## **TECHNICAL BULLETIN**

**505-24-31**  
6 February 2025

**SUBJECT:** ENGINE OIL TANK SIGHT GLASS, INSPECTION AND REWORK OF

Figure 1 – Internal View of the Sight Glass with Excessive Sealant Shown

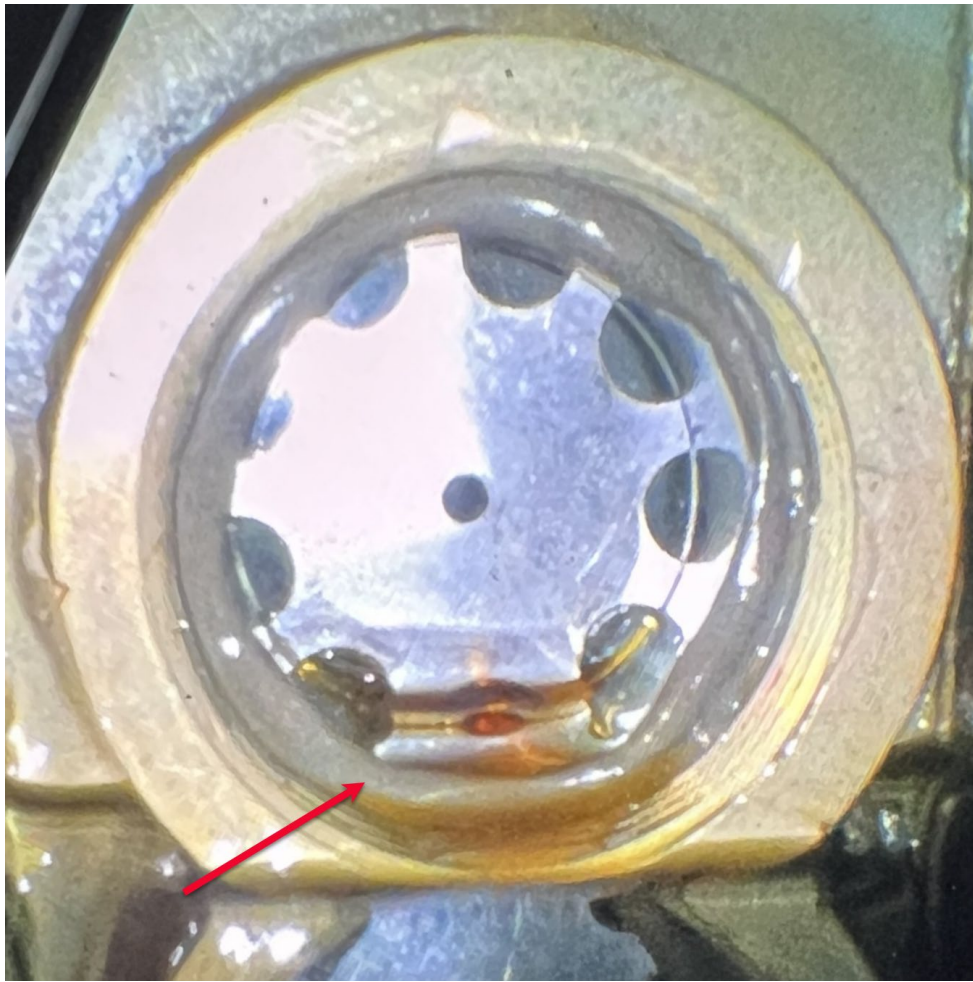
Bell has been made aware that some 505 oil tanks SLS-065-100-037 and -065 have been manufactured with excessive sealant applied to the sight glass threads during installation. The excessive sealant squeezes out the back side of the sight glass and creates a dam (Figure 1), which traps oil at the bottom of the sight glass and presents a false oil level indication (Figure 2). In most cases reported to Bell, this false oil level is clearly below the MIN line. Since the engine oil level check is called out in the 505 Flight Manual postflight check, we encourage operators and maintainers to top up the engine oil per the 505 Maintenance Manual when the oil level is found below the MIN line during the postflight check.

This TB provides procedures to inspect the engine oil tank sight glass for the presence of excessive sealant. If sealant is found to be exceeding the limit specified in this TB, the sight glass should be removed and re-installed per the procedure in this TB.

Figure 3 – Sealant Application to the Sight Glass Threads

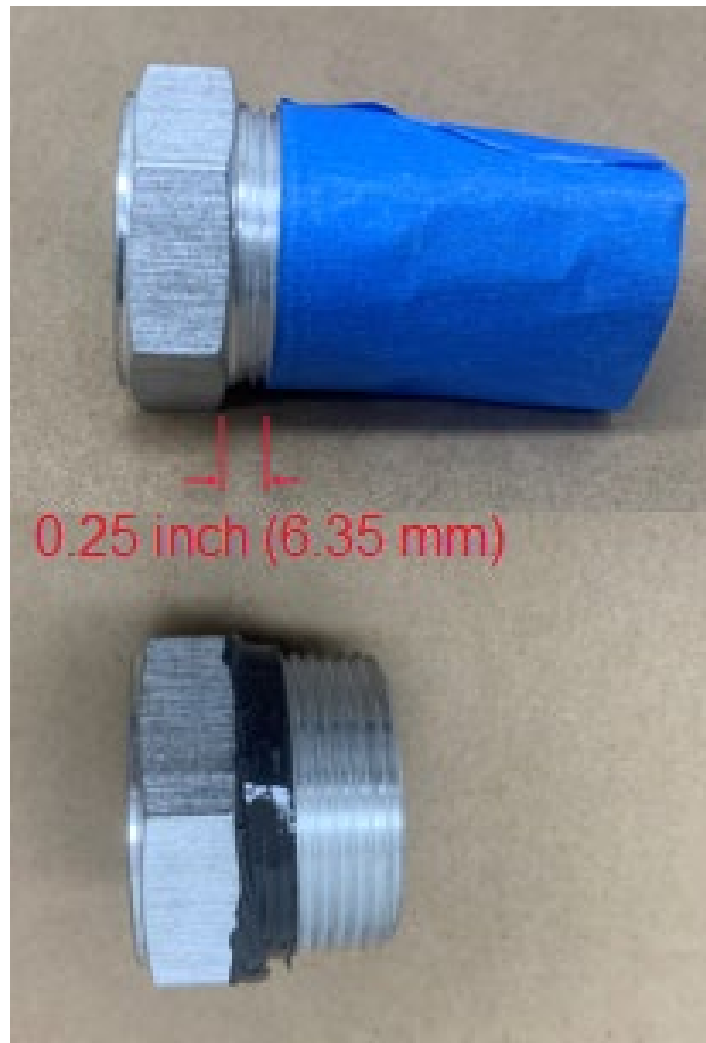
13. Dry the oil tank and the sight glass with shop air.
14. Apply sealant (C-308) to the top 0.25 inch (6.35 mm) of the sight glass threads and the bottom face of the hex per Figure 3.
15. Wet install the sight glass into the oil tank sight glass boss.
